SHOPS @ MCLAUGHLIN II PEYTON, CO FINAL LANDSCAPE PLAN	THIS PLAN SHALL NOT BE COPIED WITHOUT THE PERMISSION OF NDS, INC.	VATURAL DESIGN SOLUTIONS Landscape Architecture	Land Planning · Irrigation Design 5539 Colt Drive, Longmont, CO 80503 (303) 443-0388 · neil@ndscolorado.com
SHOPS			PLAZ PLAZ
	@ MCLAL	PEYTON, CO	INAL L

Markup Summary

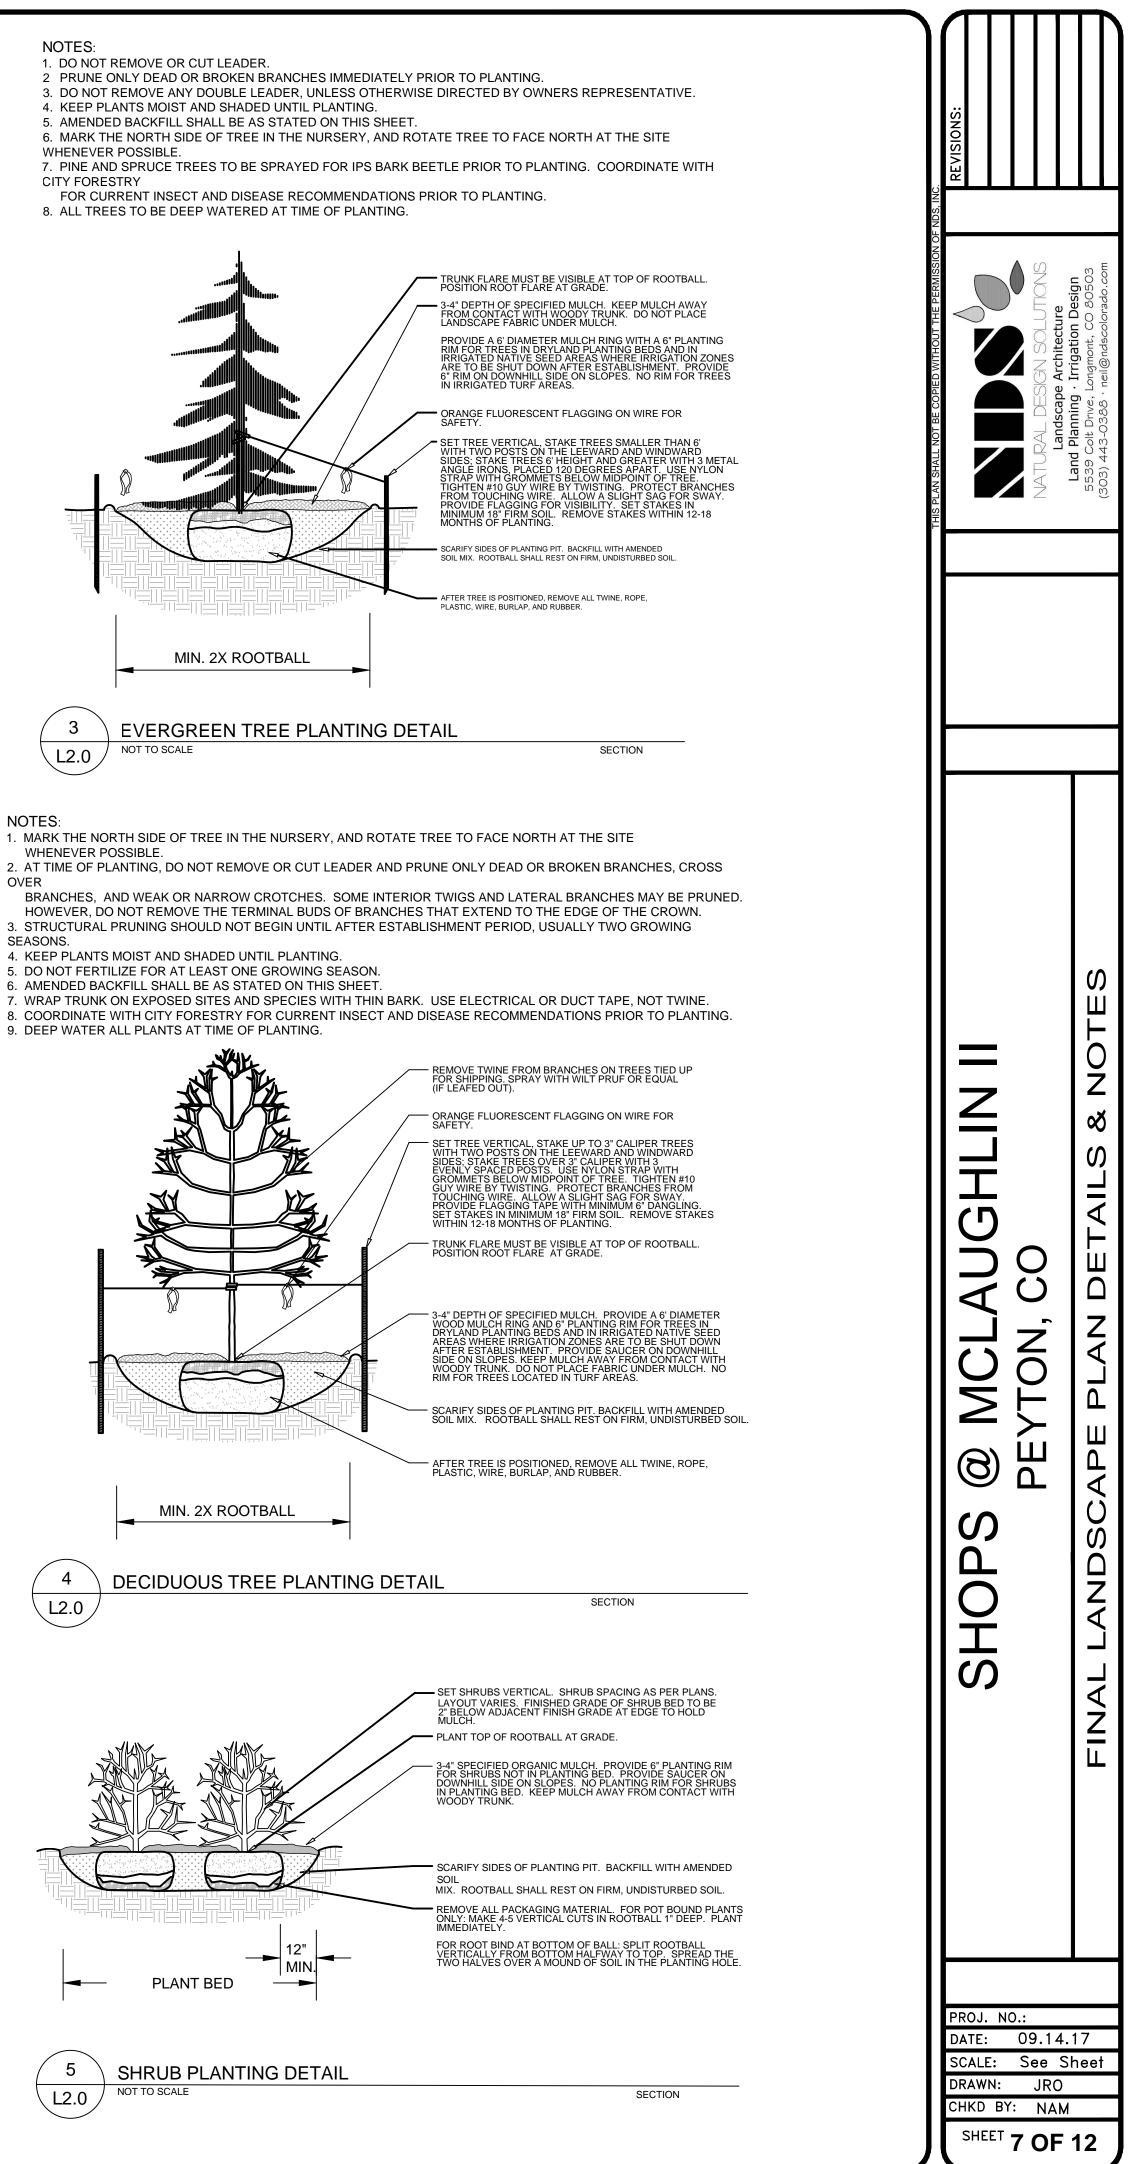
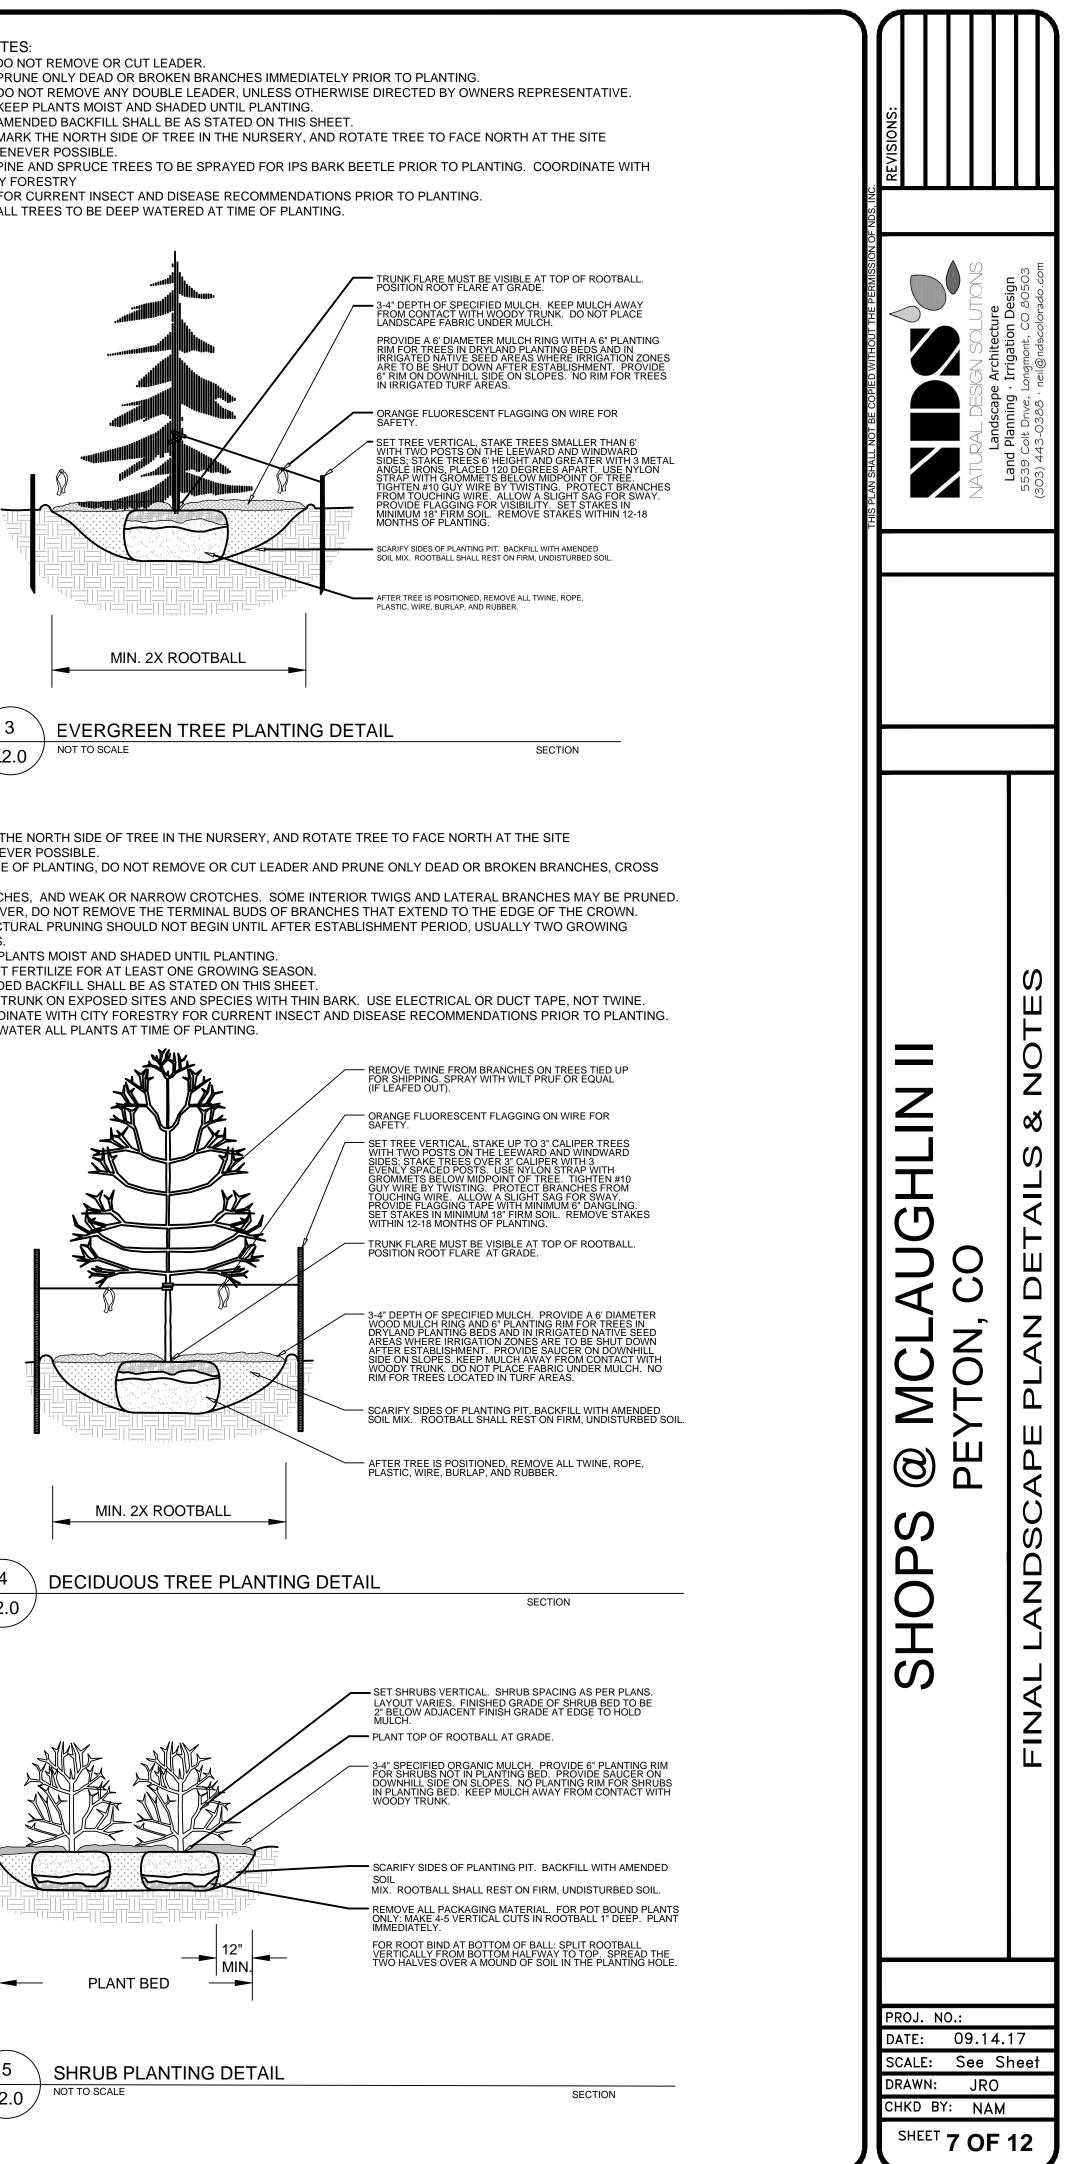
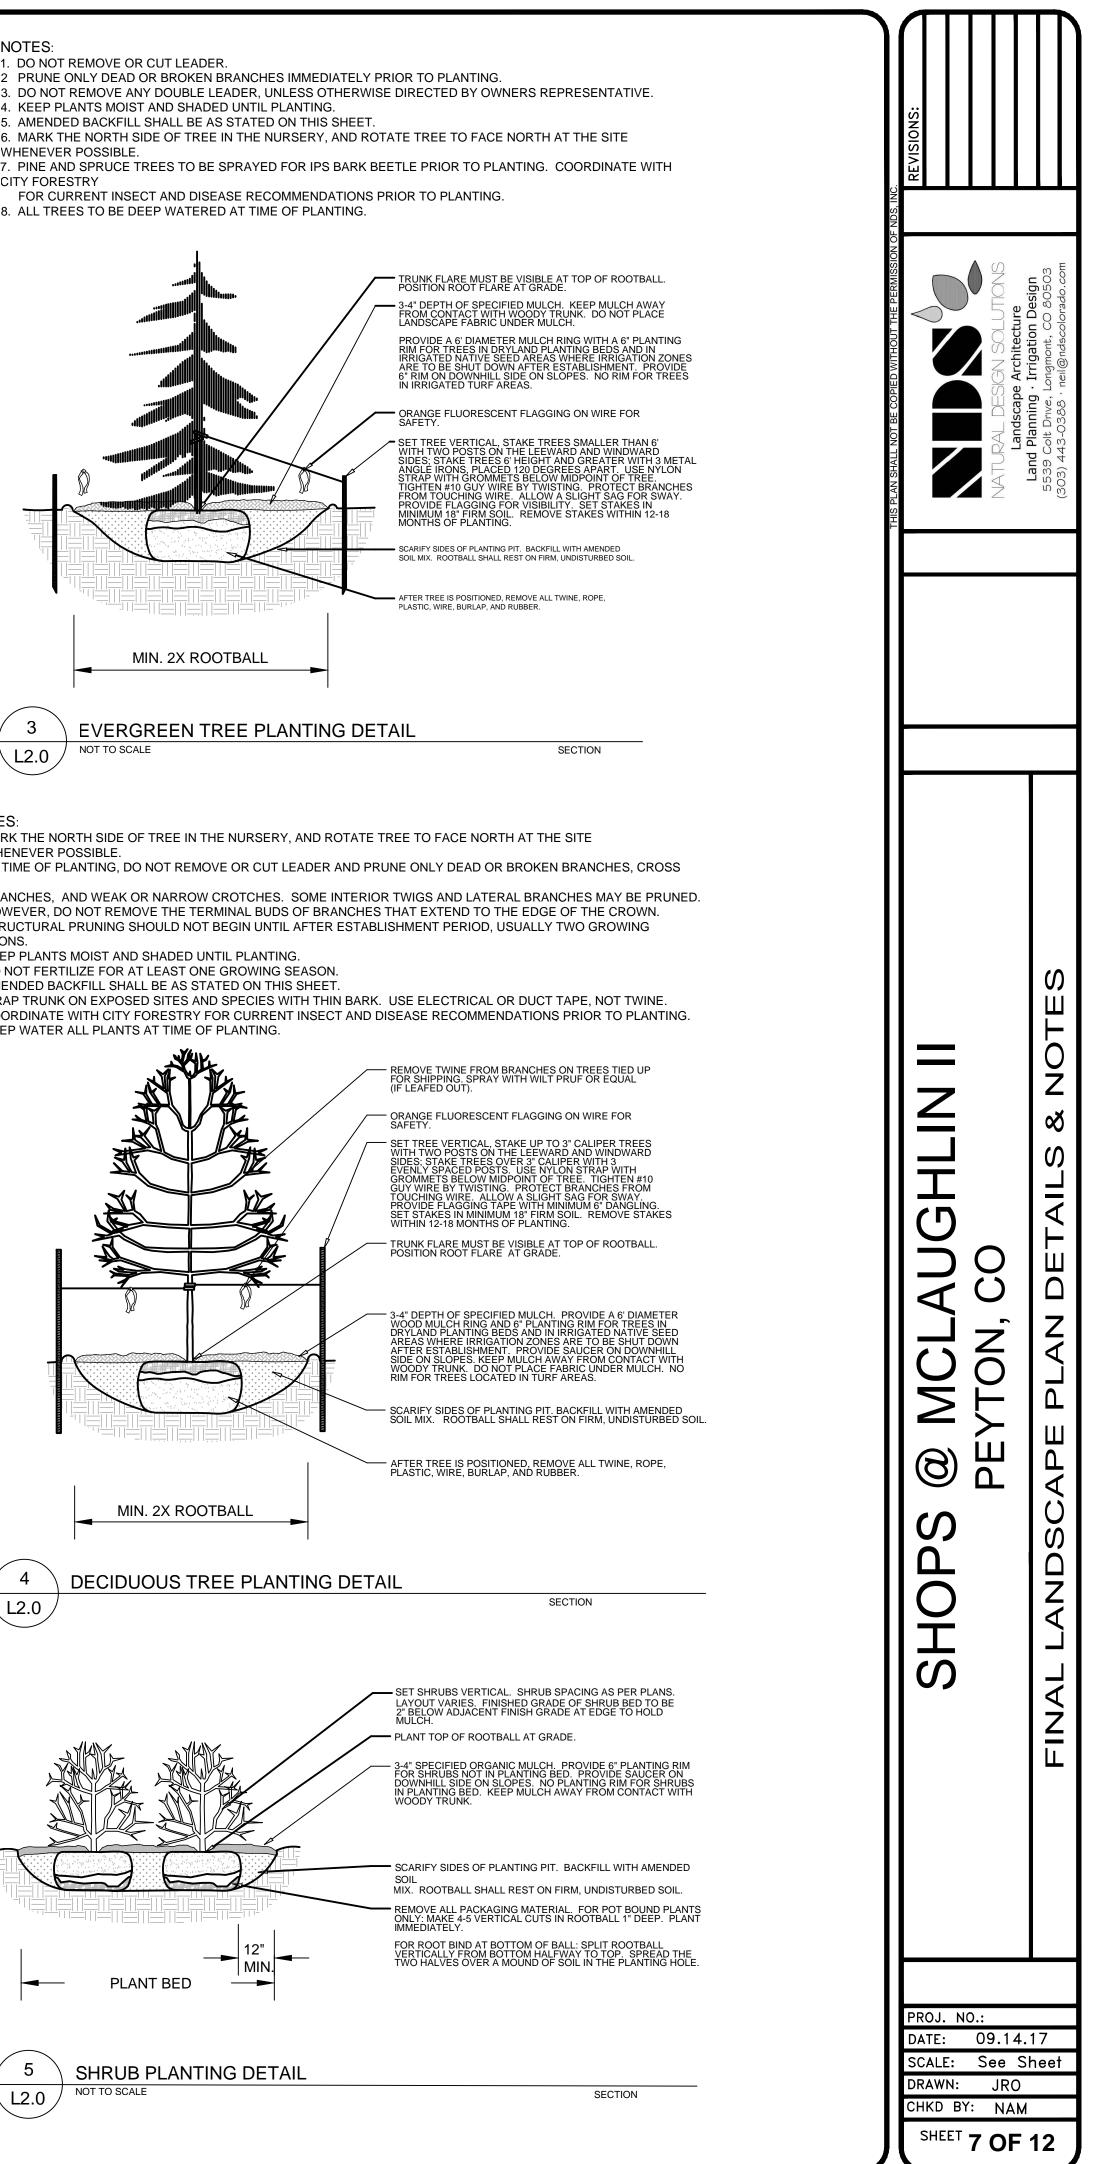
rock/mulch along roadways to minimize water usage and potential maintenance issues

Staff supports utilizing
